Public Comment No. 1153-NFPA 70-2021 [Global Input]

The Correlating Committee directs the Chair of CMP-13 to assign a task group to review all the definitions under their purview for compliance with the NEC Style Manual and to review definitions identified by the Correlating Committee that may contain correlation issues. The attachment includes a list of those definitions identified that need to be reviewed.

First Revision No. 9192-NFPA 70-2021 [Global Input]

**Figure Informational Note Figure
700.32 Emergency System Selective
Coordination.**

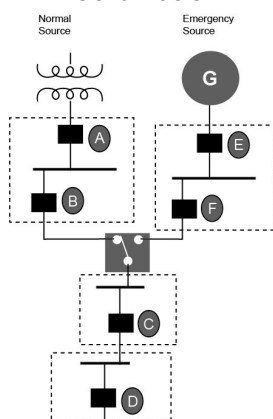
Informational Note: See Informational Note Figure 700.32 for an example of how emergency system OCPDs selectively coordinate with all supply-side OCPDs.

OCPD F selectively coordinates with OCPD E.

OCPD B is not required to selectively coordinate with OCPD A because OCPD B is not an emergency system OCPD.

**Figure Informational Note Figure
701.32 Legally Required Standby System
Selective Coordination.**

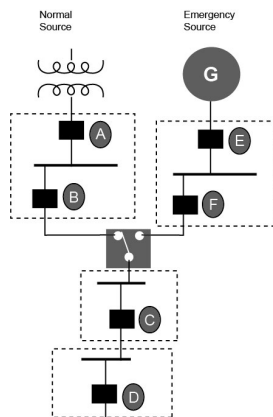
Informational Note: See Informational Note Figure 701.32 for an example of how legally required standby system OCPDs selectively coordinate with all supply-side OCPDs.

OCPD F selectively coordinates with OCPD E.

OCPD B is not required to selectively coordinate with OCPD A because OCPD B is not a legally required standby system OCPD.

**Figure Informational Note Figure
708.54 Critical Operations Power System
Selective Coordination.**

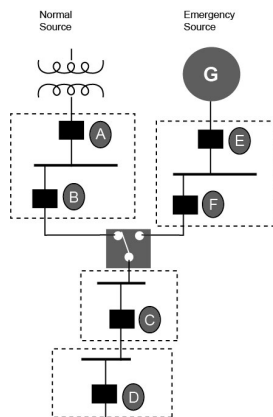
Informational Note: See Informational Note Figure 708.54 for an example of how critical operations power system OCPDs selectively coordinate with all supply-side OCPDs.

OCPD F selectively coordinates with OCPD E.

OCPD B is not required to selectively coordinate with OCPD A because OCPD B is not a critical operations power system OCPD.
